2250 Crystal Drive & 223 23rd Street

September 2022

# **Program Overview**

## **Tower Massing Update**

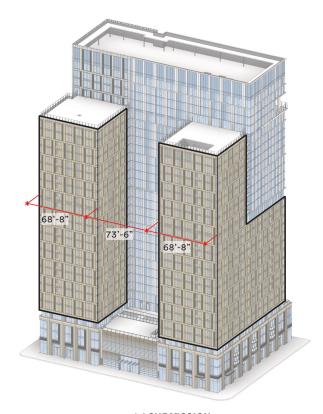
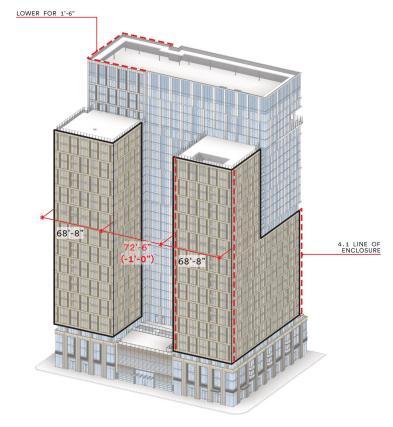
- Presented a revised massing option introducing 5' setbacks above the podium on all sides
- Irregular sculpting was required to implement the setbacks
- The Community preferred the original sculpting

- Applicant has worked with Staff on a more targeted increase to setback on Crystal Drive
- Increased articulation along Crystal Drive and of building top
- Preserves the original design intent favored by the community

## County Comments: Park Facades

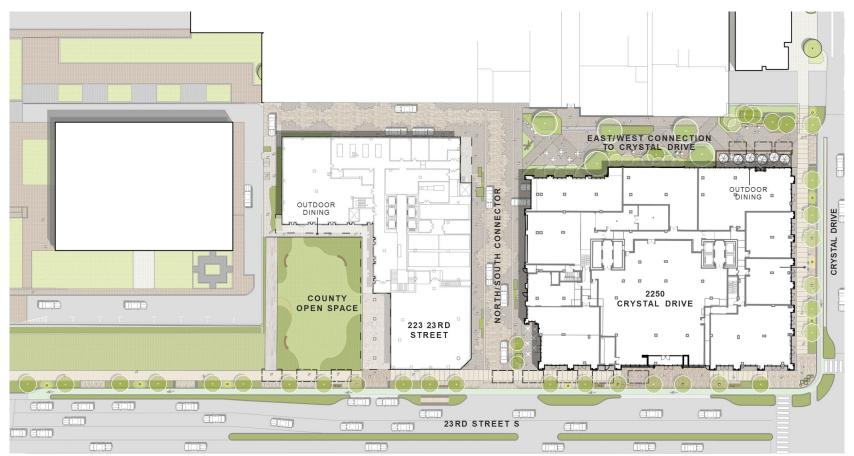
- Consolidate retail frontage around open space
- Acknowledge west front along future Clark Bell Street

# Park #10 Updates

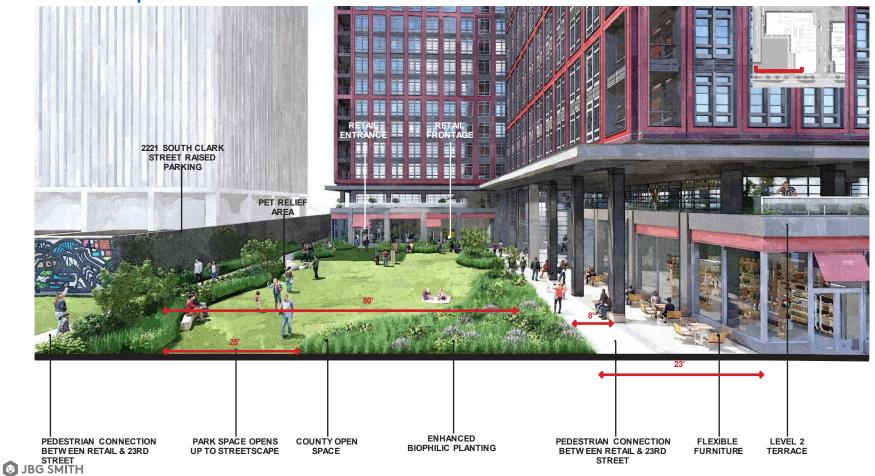
- Desire for a more developed interim park design, more seating, and more opportunities for activation
- The Community voiced concerns regarding a lack of designated pet relief areas

- Additional planting zones with integrated seating
- Added a designated pet relief area

## **East/West Connection Updates**

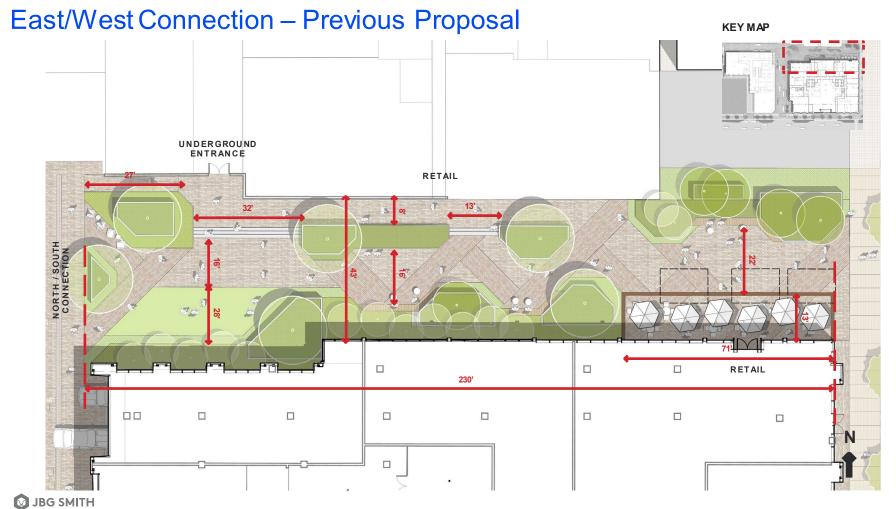
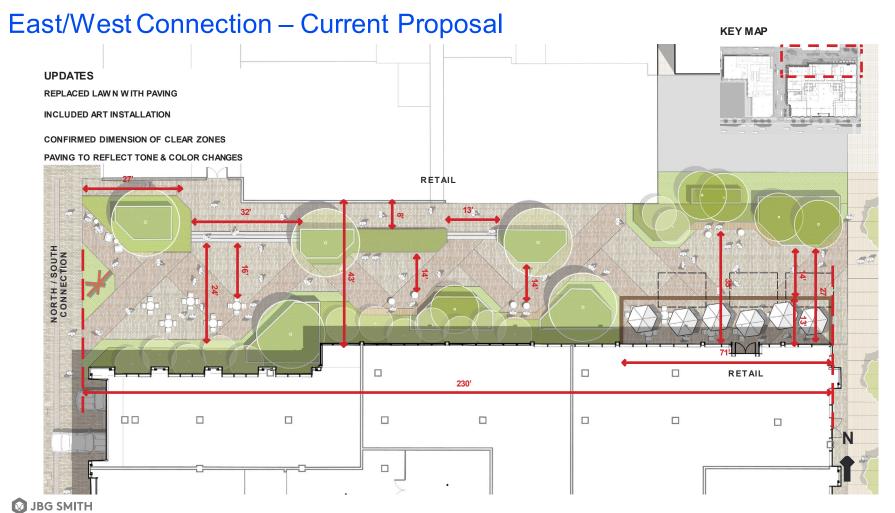
- What We Heard
  - Concerns regarding a lack of activation areas
  - Desire for a public art installation
- Current Proposal
  - Additional active open space was added
  - A public art installation was added to aid in activation and wayfinding
